Supporting Statement for Applications
[refs. DM/25/2654 and 2655]
Wykehurst House, nr Bolney RH17 5QQ

Rev B 14.04.2026

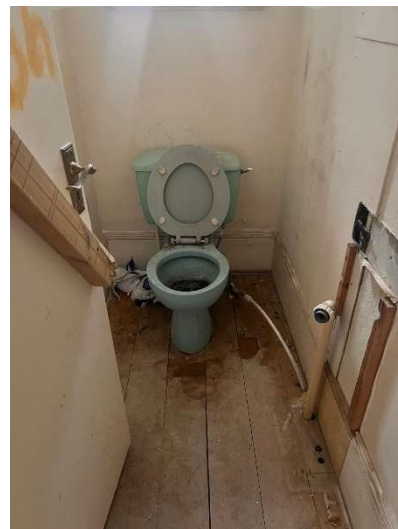
The submitted email from Mittens Plumbing and the accompanying Water Services plans are not sufficient for a full understanding of the work which has been undertaken, the justification for it, or its potential impact on historic fabric (it is understood that this aspect of the proposal is retrospective).

A more detailed condition report of the previously existing water system should be provided, alongside a detailed schedule of the new work which has been undertaken. Separate existing and proposed plans should be provided- it is not clear which we currently have in front of us, and no indication of changes to pipe routes etc. is given. The Heritage Statement should be expanded to give a more detailed consideration of the impact on the historic fabric of this work.

Modern plasterboard ceiling with new pipework run in void above.

Modern, harmful pipework addition

Examples of 70s plumbing additions including supplies and drainage tracking around rooms and penetrations through fabric.

Proposed floor standing cast iron radiator

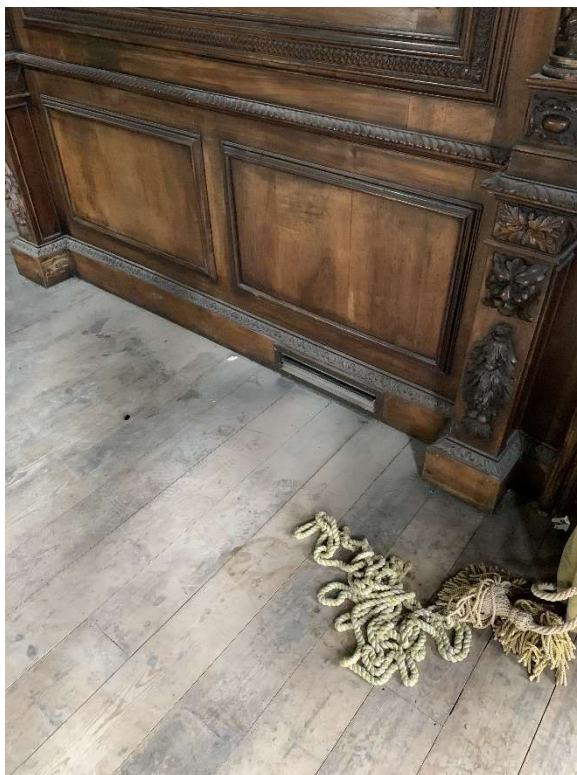
Further information is required to describe the proposals in this respect, including more detailed existing and proposed plans highlighting any new work, and a detailed schedule of works. A more detailed consideration of the impact on historic fabric should also be provided.

Non-original grille, connected to the duct system

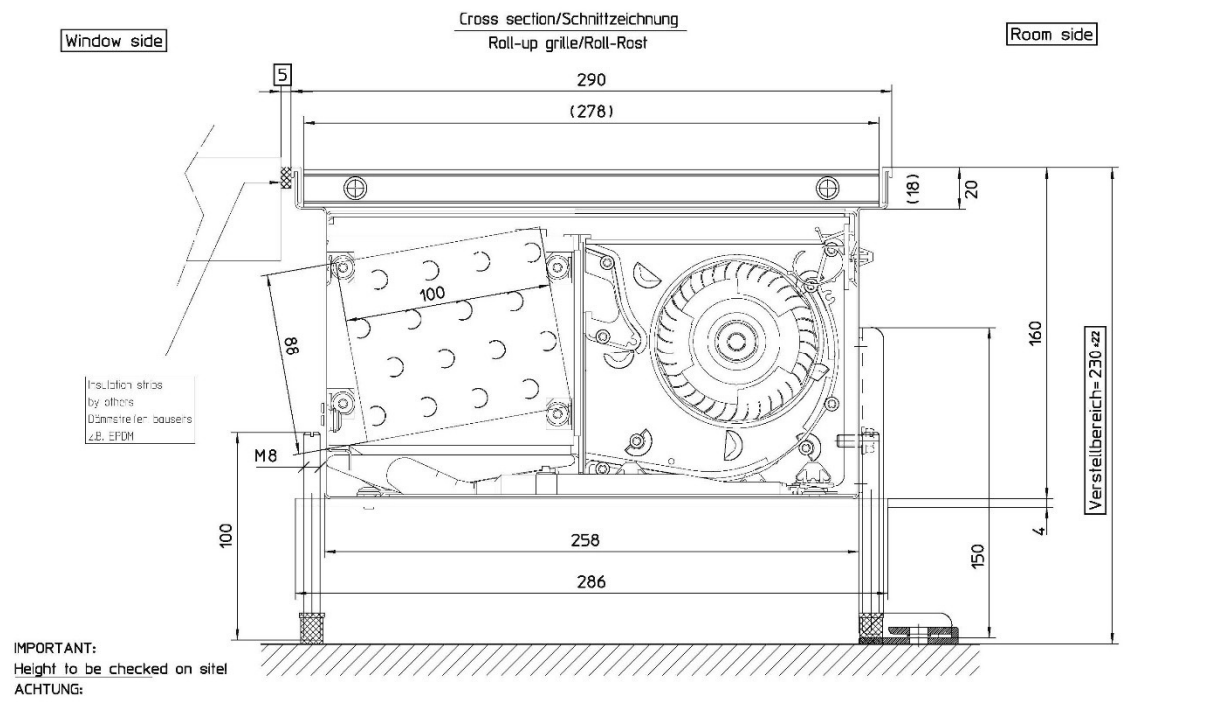
The information in this respect is inadequate. There is no indication of whether this work has already been undertaken or not. There is no detail beyond what appear to be plans of feeder pipes(?) at basement and ground floors of the extent or nature of the system, its relationship with the existing floor structures/finishes, or the extent of any impact on historic fabric. More detailed plans, including room plans and typical sectional details, should be provided, alongside a detailed methodology and impact statement.

We attach below a detail of the proposed product, for consideration. The proposed method of installation involves the trimming and bridging of existing floor joists to accommodate the new trench heater box width. The grille itself is rolled into a floor rebated 'tray' so that only the grille is visible inside a fine outline (the tray lip).

The adjacent photograph shows exploration of the existing dining room floor void, revealing modern timber supports below and a void of sufficient depth to hold the proposed trench heater product. Only the grille being visible, flush to the floor.

The floor joists below will be 'trimmed' locally to provide space for the heater, requiring one joist to be cut-out, with the ends re-supported by perpendicular double timbers, spanning between the remaining joists.
